OICA COMMENT ON DRAFT AMENDMENTS TO REGULATION No. 83

A. PROPOSAL

Annex 4, Appendix 1, Table 1.2

Figure 1/2
Elementary urban cycle for the type 1 test

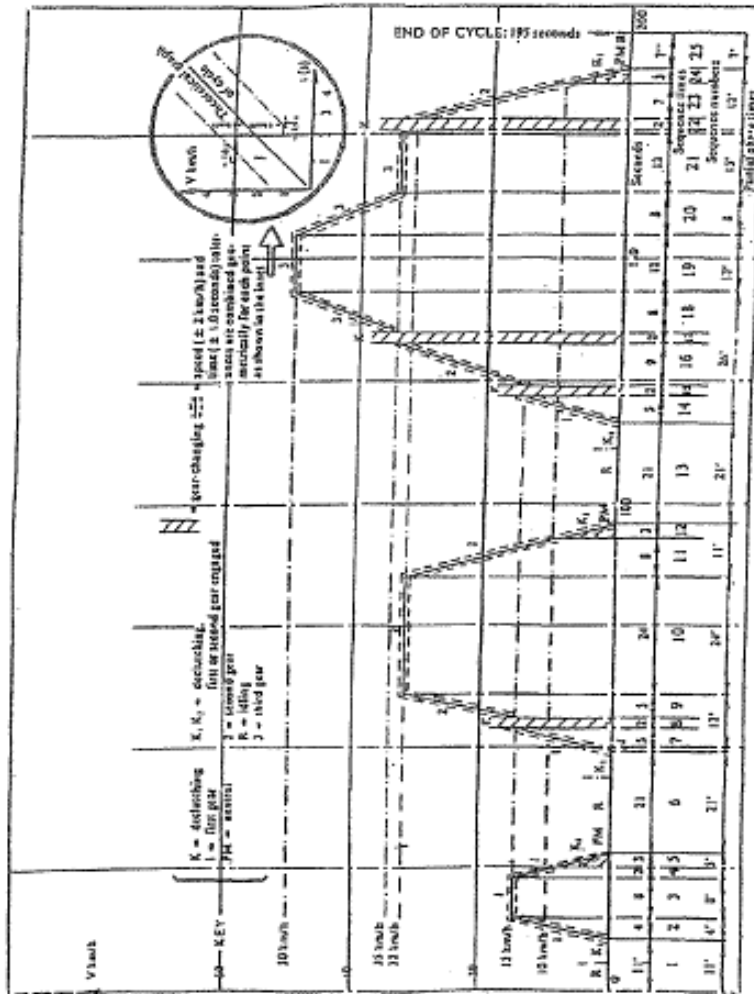
In operation No. 23, correct the speed (km/h) "32-10" to read "**35-10**".

Harmonization with EU Directive 70/220/EEC as amended by 98/69/EC.

Figure III.1.1
Operating cycle for the Type I test

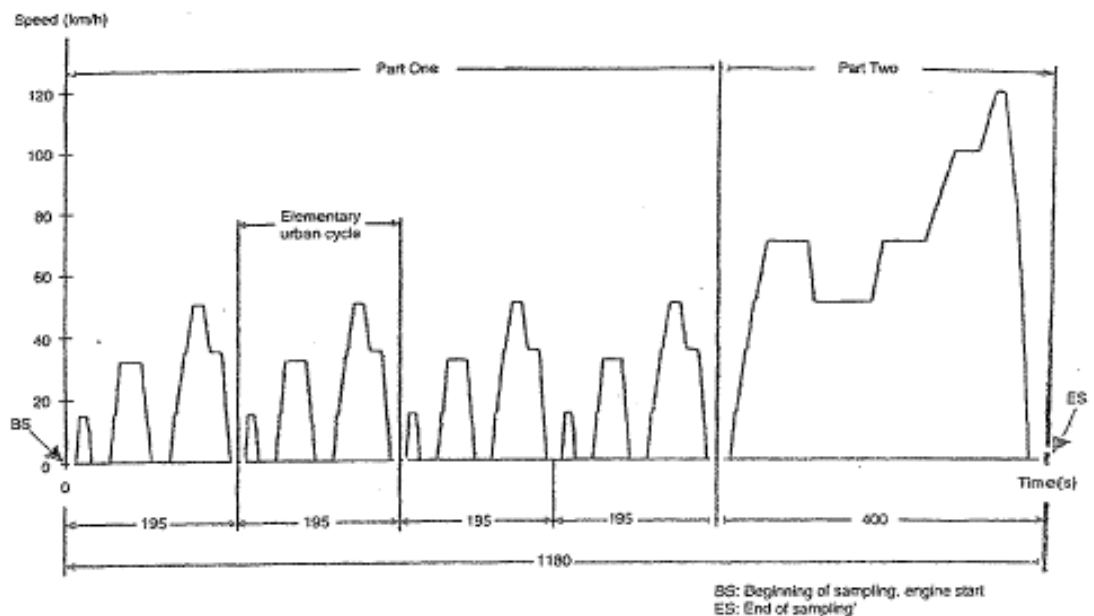
- Figure III.1.1 is replaced by the following new figure:
